STATE OF RHODE ISLAND AND PROVIDENCE PLANTATION
DEPARTMENT OF TRANSPORTATION
RHODE ISLAND CONTRACT NO.2011-CH-092
FEDERAL-AID PROJECT NO. FAP Nos: 405-421-612

CHILD STREET (ROUTE 103), FROM STA 11+00 TO STA 106+00
CITY/TOWN OF Warren
COUNTY OF BRISTOL

NOTICE TO PROSPECTIVE BIDDERS

ADDENDUM NO. 2 Prospective bidders and all concerned are hereby notified of the following changes in the Plans, Specifications, Proposal and Distribution of Quantities for this contract. These changes shall be incorporated in the Plans, Specifications, Proposal and Distribution of Quantities, and shall become an integral part of the Contract Documents.

3. General Plan 2

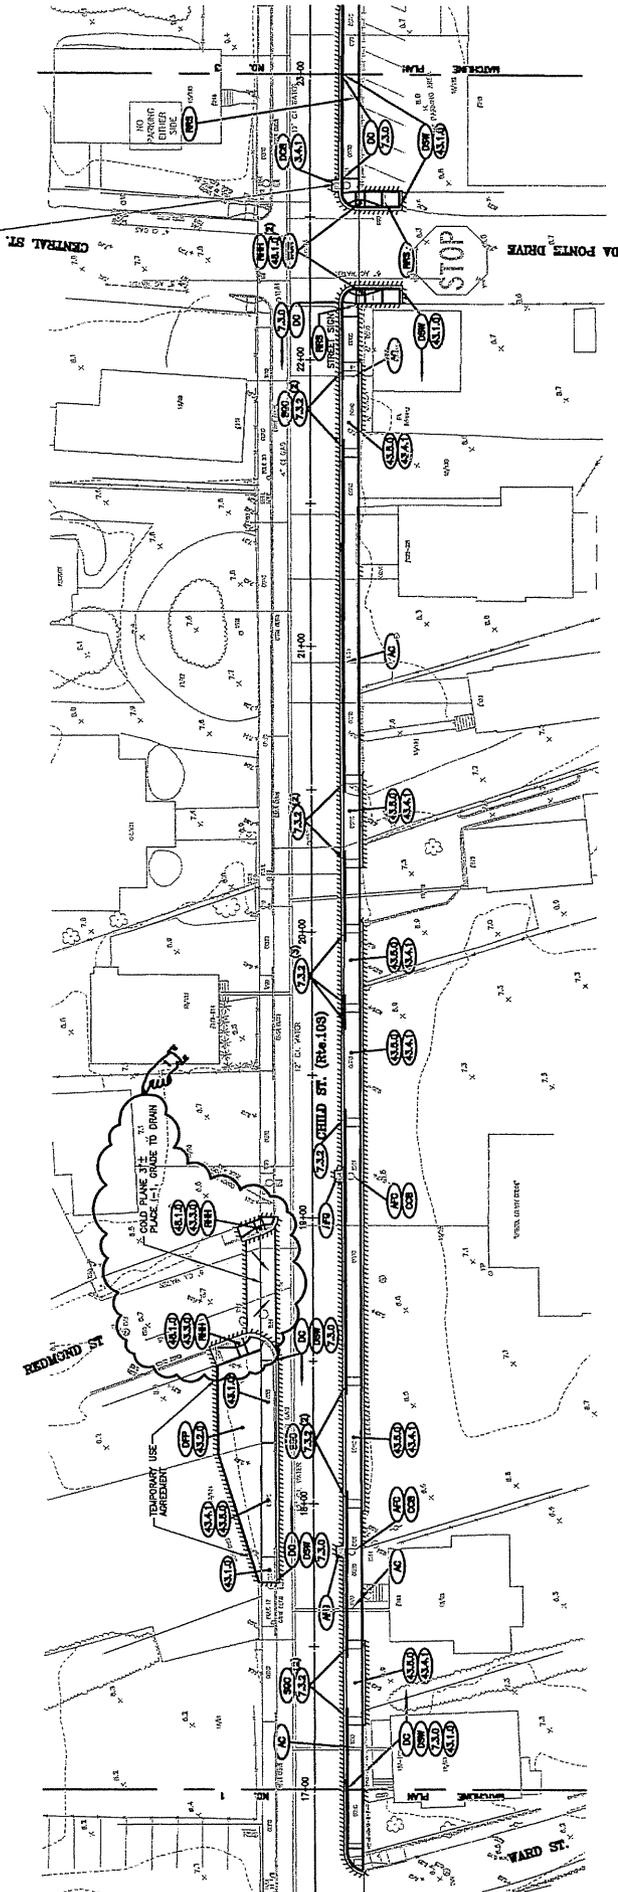
Delete General Plan 2 in its entirety and replace it with General Plan 2 (R-1) attached to this Addendum No. 2. Cold Planing and Overlay has been added to Redmond Street.
